Access Compliance Report

Public Rights-of-Way

(Curb Ramps)

Intersection ID: 18484	Main Street: FOXCROFT_WOODS_LN	Cross Street: SHARON_RD	Location: SE
ADA ID: 578550EEFB83	Ramp Type: PerpDiag	Initial Pass/Fail: Fail	Overall Compliance: No
Severity Score: 35			
Codes/Mitigation Info/Possible Solution		Field Measurements/Component Compliance

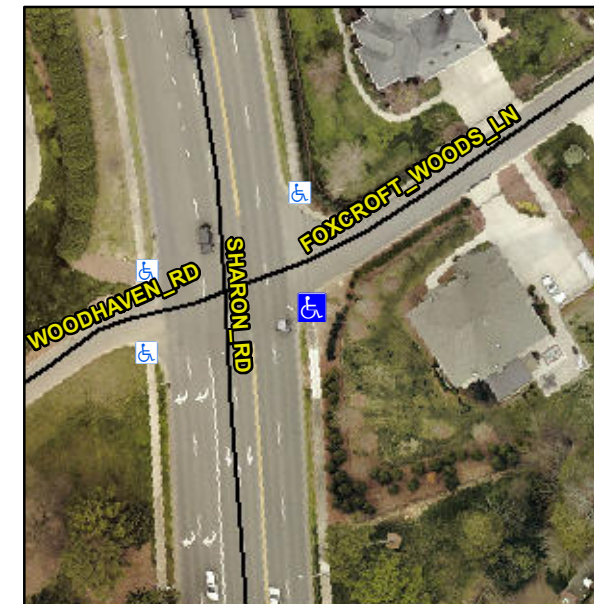
R304.5.1, R304.2.2, R304.5.3

Compliance	Description	Data	Compliance	Description	Data
N/A	Ramp Length (in)	51.0	No	Ramp Slope (%)	13.3
No	Ramp Width (in)	43.0	No	Ramp XSlope (%)	2.5
N/A	Flare Type LT	N/A	N/A	Flare Type RT	N/A
N/A	Flare Slope LT (%)	N/A	N/A	Flare Slope RT (%)	N/A
N/A	Flare Traversable LT?	N/A	N/A	Flare Traversable RT?	N/A
N/A	Landing Length (in)	N/A	N/A	DWS Provided?	N/A
N/A	Landing Width (in)	N/A	N/A	DWS Contrast?	N/A
N/A	Landing Slope (%)	N/A	N/A	DWS Length (in)	N/A
N/A	Landing X Slope (%)	N/A	N/A	DWS Full Width?	N/A
N/A	Landing Curb? (Y/N)	N/A	N/A	DWS Offset (in)	N/A
N/A	Shared Landing?	N/A			
N/A	Gutter Ponding?	N/A	N/A	Gutter Slope (%)	N/A
N/A	Gutter Lip Ht (in)	N/A	N/A	Gutter X Slope (%)	N/A
N/A	Painted X Walk1?	No	N/A	Painted X Walk2?	No
	X Walk 1 Direction	To N		X Walk 2 Direction	To W
N/A	X Walk 1 Width (in)	N/A	N/A	X Walk 2 Width (in)	N/A
	X Walk 1 Slope (%)	1.3		X Walk 2 Slope (%)	2.7
	X Walk 1 X Slope (%)	3.1		X Walk 2 X Slope (%)	1.2

Remove & Replace Curb Ramp With Two New Directional Ramps or Equivalent.
